**Vehicle Out Of Fuel –
Range Indicated On Message Center –
Modify Transfer Pipe**

MODEL 2002 MY
X-TYPE
VIN C00001-C39700

ILLUSTRATION 1

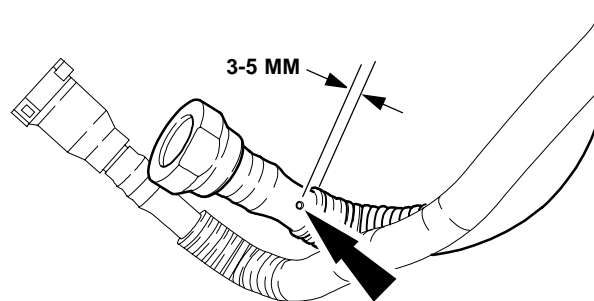
1. Remove the fuel transfer pump assembly (see Workshop Manual, JTIS CD ROM section: 310-01, SRO 19.45.06).
2. For access, reposition the return transfer pipe away from the fuel tank opening (return transfer pipe has a yellow release latch).
3. Using a 2 mm drill bit, by hand, drill a hole 3 mm to 5 mm from the shoulder (convoluted pipe side) in the return transfer pipe and remove any swarf (Illustration 1).

DRILL HOLE 3-5 MM FROM SHOULDER
